BZA Application Form

BZA Number: 165327

LOCATION OF PROPERTY: 27 Fayerweather St., Cambridge, MA

Petitioner seeks to increase height of roof of both the accessory dwelling unit structure and the existing garage.

EXISTING GARDEN WITH PROPOSED CARRIAGE HOUSE + CURRENT GARAGE (OVERLAY)

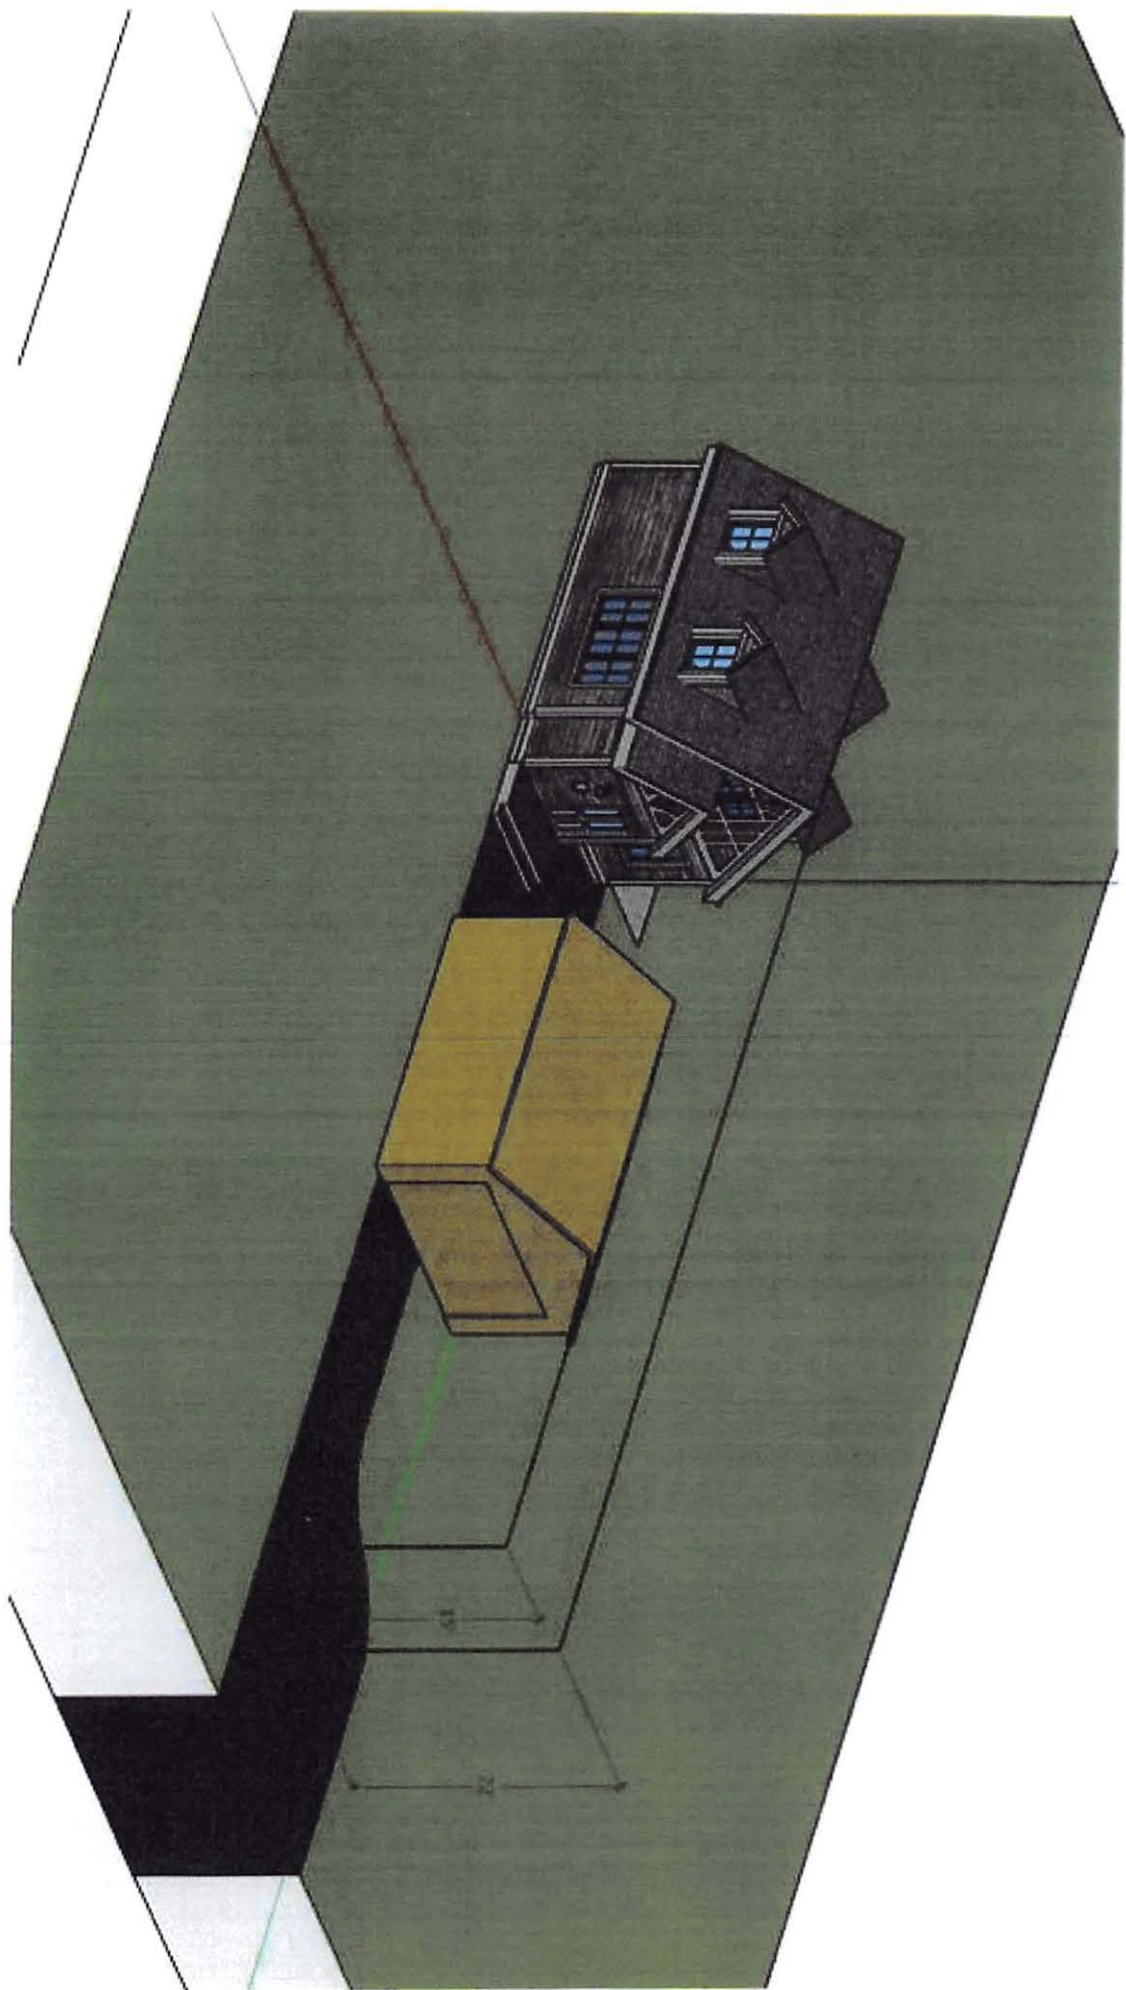
The four panel comparison study that has been prepared by our architect Greg Dennee and submitted to the Board clearly demonstrates the negative impact on our use of our patio and garden. To further illustrate for the Board the adverse effect of raising the height of both the front and rear garages, we engaged the services of our contractor, Kistler and Knapp Builders, Inc. to install four twenty-two foot high poles along the property line. Submitted herewith is a photo of the rear yard patio and garden that depicts the two rear poles placed along the boundary line facing the rear garage, showing the open space that the roof of the proposed accessory building would be filling in. Also submitted herewith are a photo looking from the rear patio toward the two front poles that were placed next on the side of our house facing the front garage, and a photo from the second floor window looking over the existing front garage with the same two front poles in place.

to the building and site plans prepared by Allison Dingman. We exported the model to a program known as Lumion, whereby we simulated lights, landscaping and context. We then matched the photograph supplied by Ms. Flanagan to the Lumion images, using Photoshop, and produced the four “before and after” attached visuals for comparison.
